Sent: 2/05/2019 10:56:52 AM
Subject: RE: DA2019/0335 - 84 HILMA STREET COLLAROY PLATEAU
Attachments: Objection Letter dated 2 May 2019.pdf;

RE: DA2019/0335 – 84 Hilma Street, Collaroy Plateau

RE: 84 HILMA ST, COLLAROY PLATEAU
OBJECTION TO APPLICATION No. DA2019/0335

Appendix B - Photo from 45 Idaline Street looking south-east

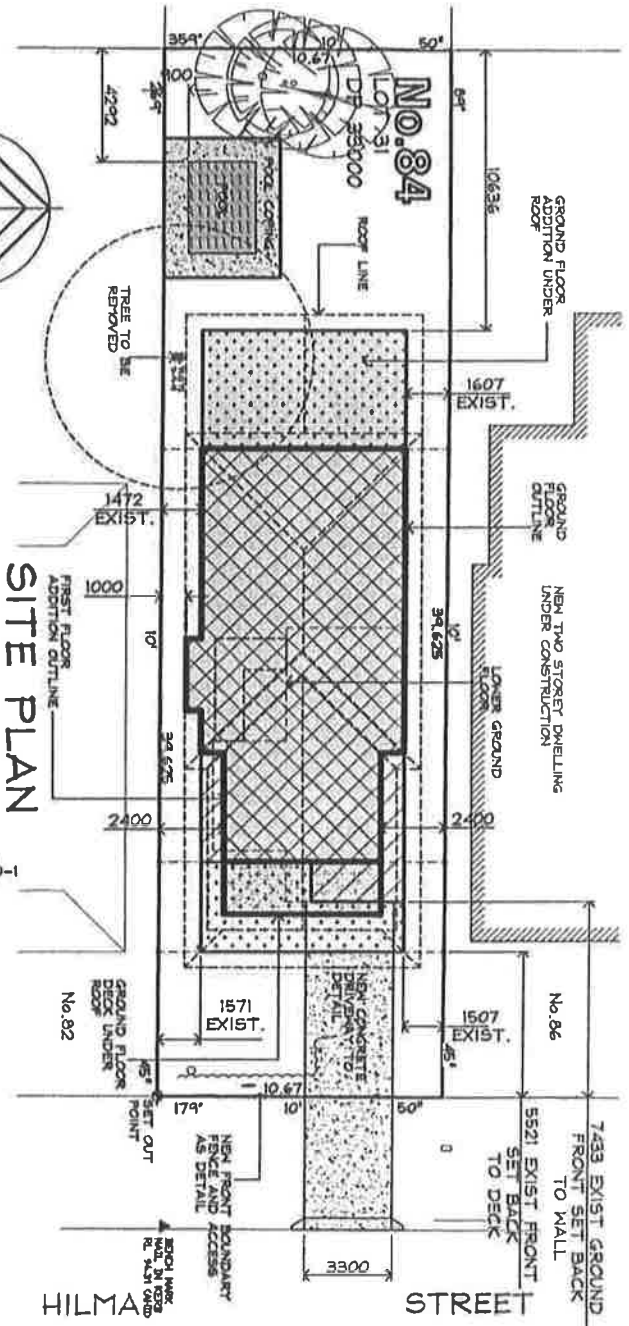
Furthermore the proposed first floor addition will have a significant and detrimental impact to our client's property, primarily, but not limited to, the impact on their views to the Long Reef Golf Course and Headland. Please see attached photograph with a mark-up of the view impact at Appendix B.

The approval of the submission will result in the unacceptable view loss of iconic headland views of Long Reef to the south-east across the rear boundary of our client's property, in conflict with the view sharing principles established in Tenacity Consulting vs. Warringah Council determination.

SOUTHERN ELEVATION
Scale 1:100

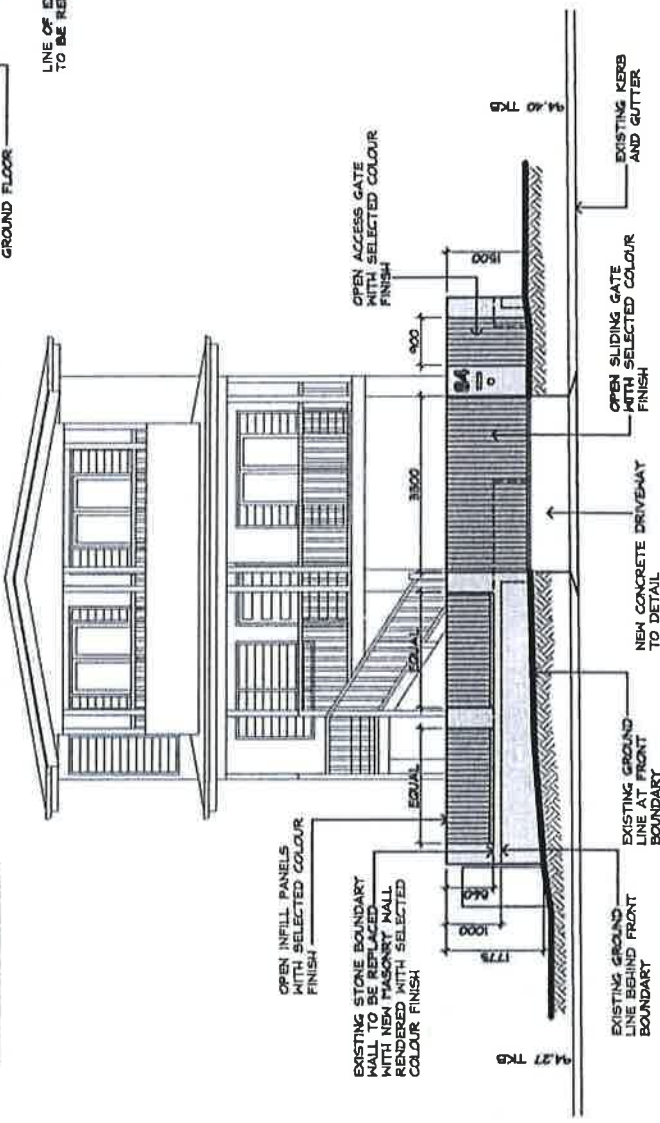
We strongly object to this height encroachment but more importantly we advise that the existing height plane has been incorrectly documented in the applicant's submission. The 8.5m height plane appears to be generated from the extrapolated natural ground line at the boundary prior to any development of the site, not the existing ground plane. The Warringah Local Environmental Plan 2011 defines the existing ground level as *"the existing level of a site at any point"* and as established by case law is taken from the underside of the slab of the lowest floor level of an existing building when measuring building height. The submission completely ignores the exiting lower ground level when defining the 8.5m height plane, significantly diminishing the impact of the breach.

In actuality, the height plane breach occurs along the first floor ridge for more than half of the top storey envelope, representing an encroachment of almost 700mm over approximately 12 metres of ridgeline – please see a mark-up of the submitted elevations at appendix A for further clarification.

EXISTING GROUND LINE SHOULD BE MEASURED FROM THE UNDERSIDE OF THE EXISTING GARAGE.

Appendix A - Submitted Elevations

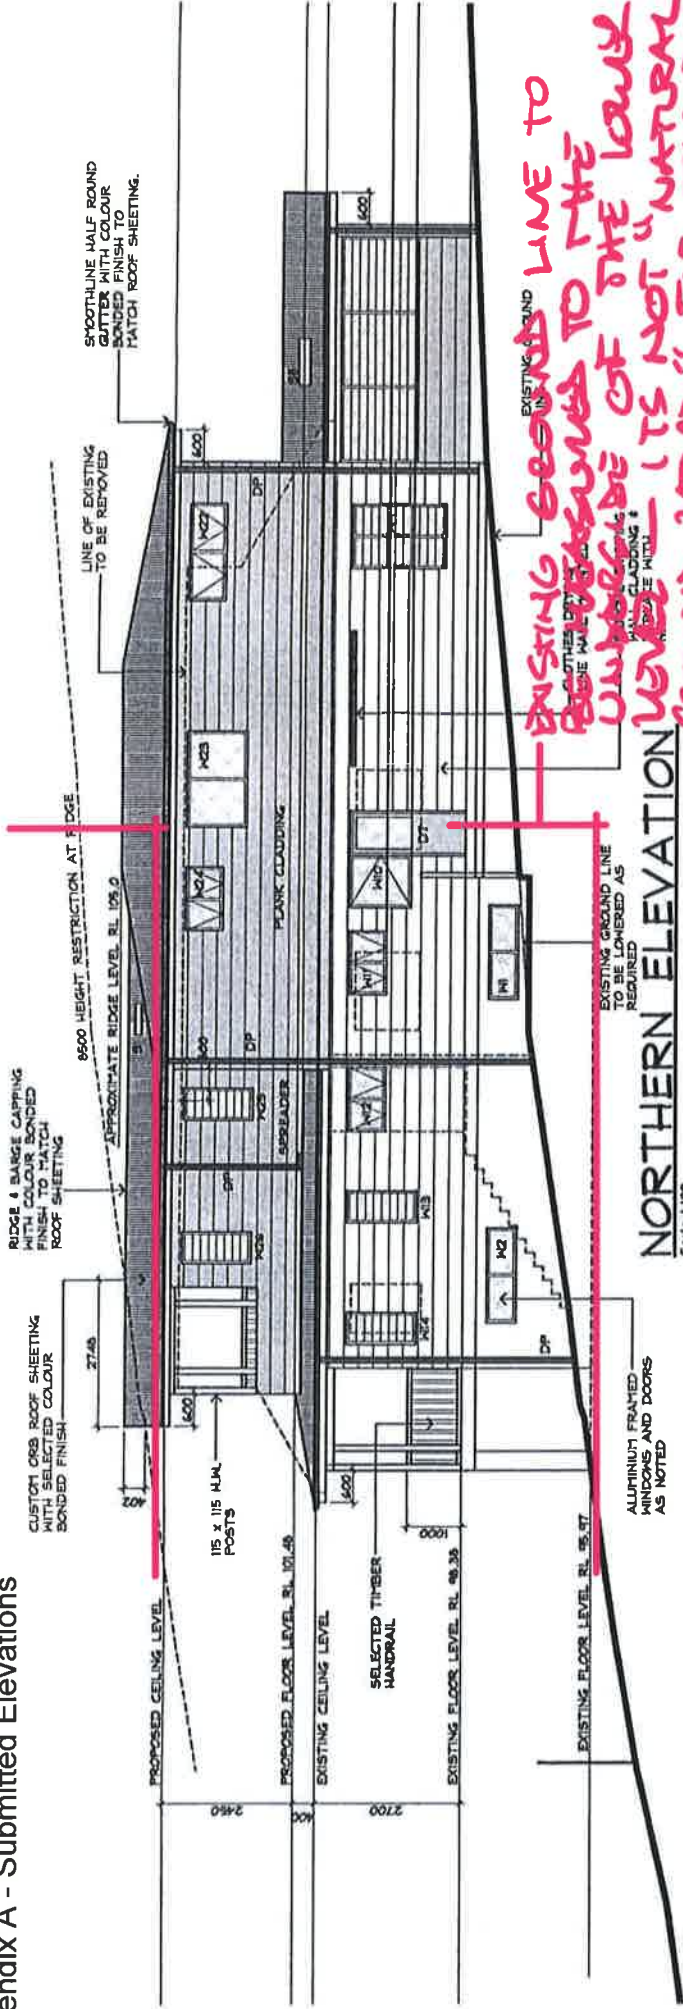
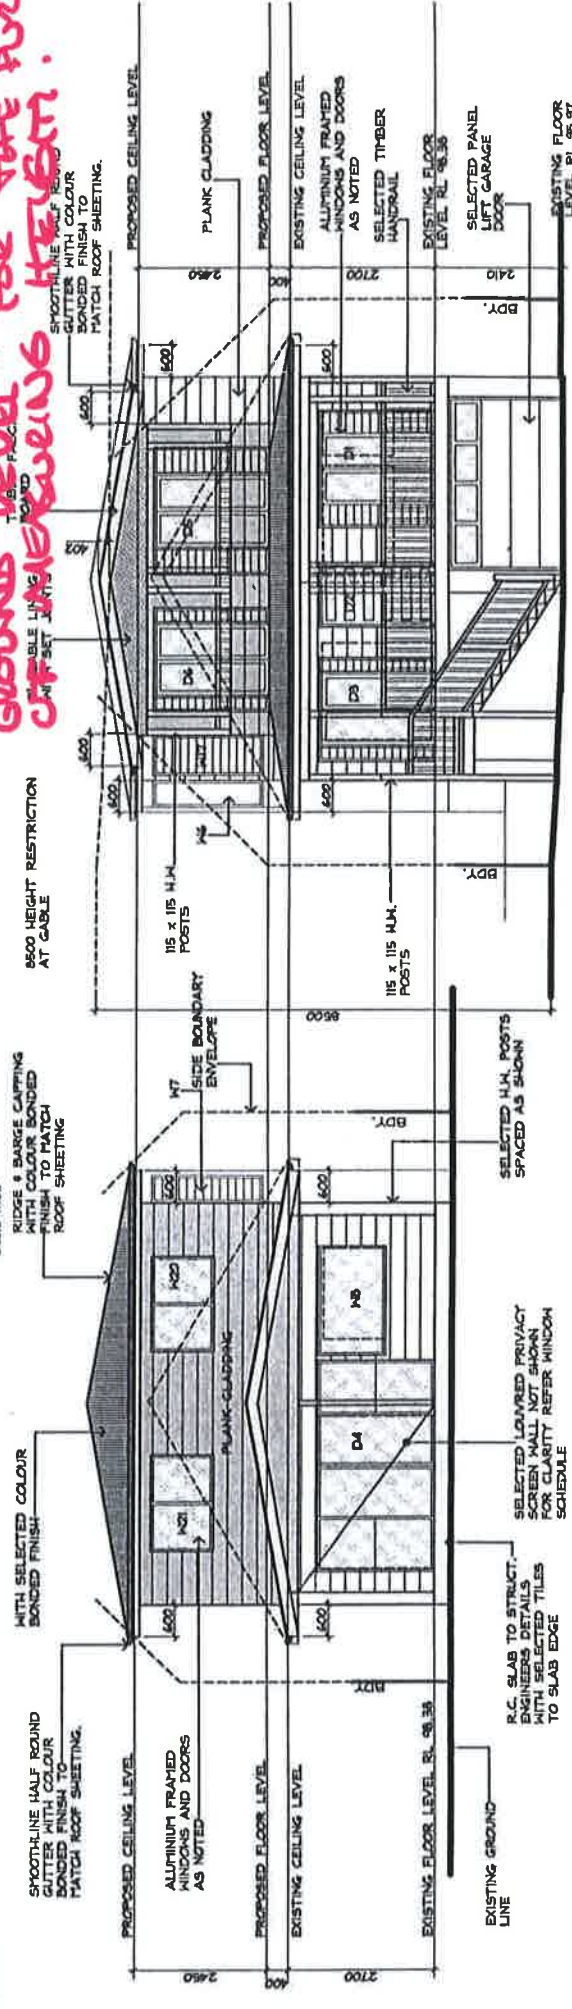
The Northern and Southern elevation diagrams depict the comparison between the existing modest cottage and the finished building and confirms that it will be wholly subsumed within the new envelope. The floor plans and elevations also confirm that there will be little if any of the original fabric retained. In the circumstances, given the extensive works, it is highly inevitable that the tokenistic portion of building to be retained, will ultimately be demolished during construction as its retention will be either financially or structurally unviable.

As per the Statement of Environmental Effects accompanying the submission, the proposal is seeking a clause 4.6 variation to breach the 8.5m height plane at the eastern ridge by 402mm via a proposed first floor addition (please see submitted elevations, drawings 181201-N2 & 181201-N3).
